Wasatch County JSPA Planning Commission November 9, 2023

SkyRidge Golf Academy -SkyRidge Golf Academy Inc.-

Final Site Plan Approval

JSPA Planning Commission Staff Report

EXHIBIT B – Site plan

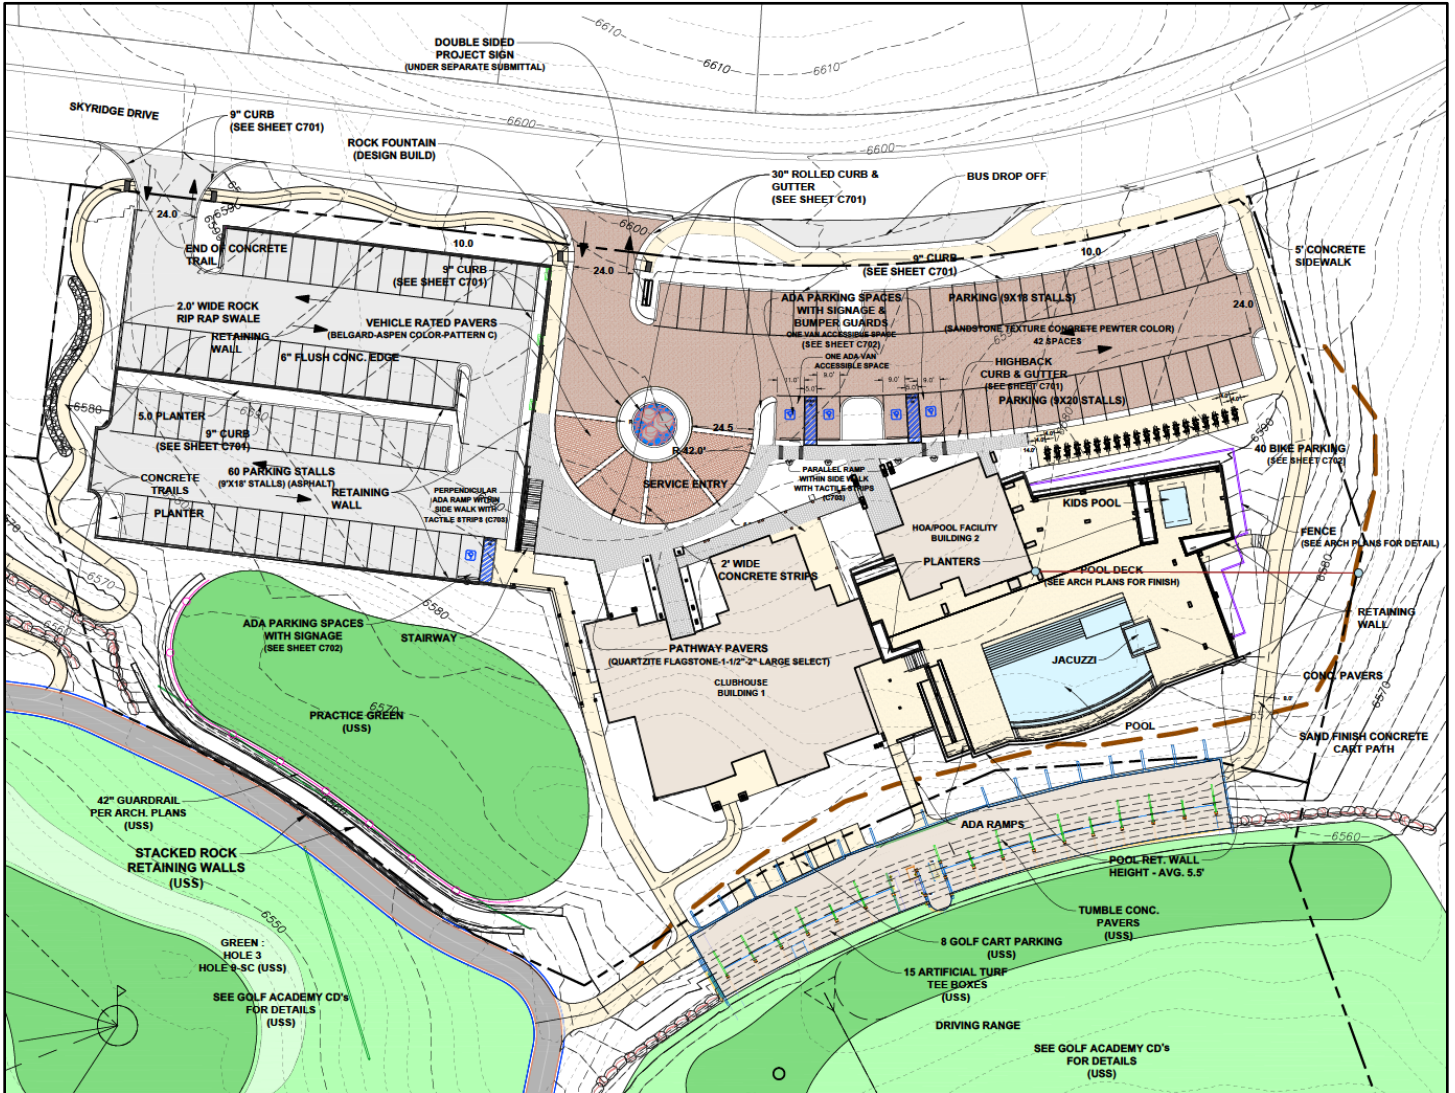
Comment ID	Sheet Name	Comment
DRC-ENG2	OTHER - ADA Access	Going to need curb cut-outs at the driveway access with tactile strips.

Comment ID	Sheet Name	Comment
DRC-PLN13	SP1 - Site Plan	Fences and enclosures around the pool must comply with all requirements of WCC section 16.21.23 including a height of at least 5' and gaps no greater than 4". I am not finding the fence detail in the architectural plan.
DRC-PLN16	12 - Landscape Plan	Include watering system and irrigation plan prepared by a landscape architect licensed in the State of Utah. (WCC. 16.21.10 C) This can be provided with the building permit application and added as a condition of approval for the Site Plan application.
DRC-PLN19	11 - Lighting and Signage	Wasatch County Code Section 16.26.14. G states the following regarding freestanding signs: "Pole Covers: All on premises freestanding signs must have the structural supports covered or concealed with pole covers (pylon covers) at least twenty four inches (24") wide. The actual structural supports shall not be exposed, and the covers must be architecturally and aesthetically designed to match the building." Please adjust the sign design to meet this requirement. This can be added as a condition to the approval to be worked out in compliance with the code.

EXHIBIT D – Landscape plan

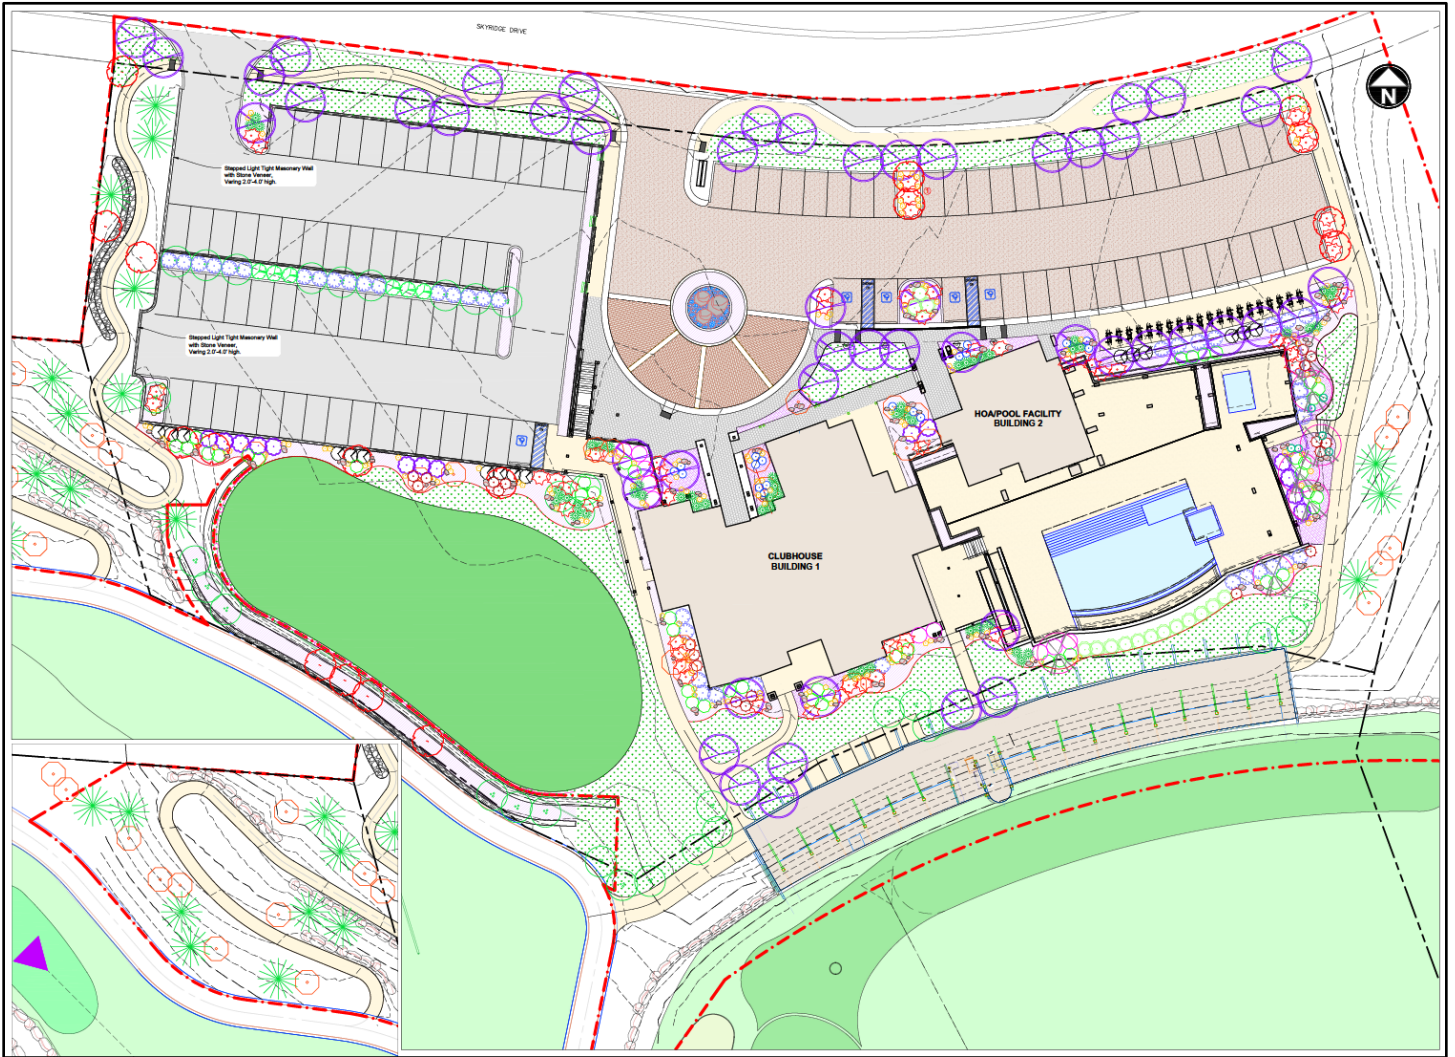
The landscaping plan does not include a watering system and irrigation plan as required by Wasatch County Code section 16.21.10. The Site Plan application decision may include a condition of approval that the watering system and irrigation plan be provided with the building permit application for the two structures.
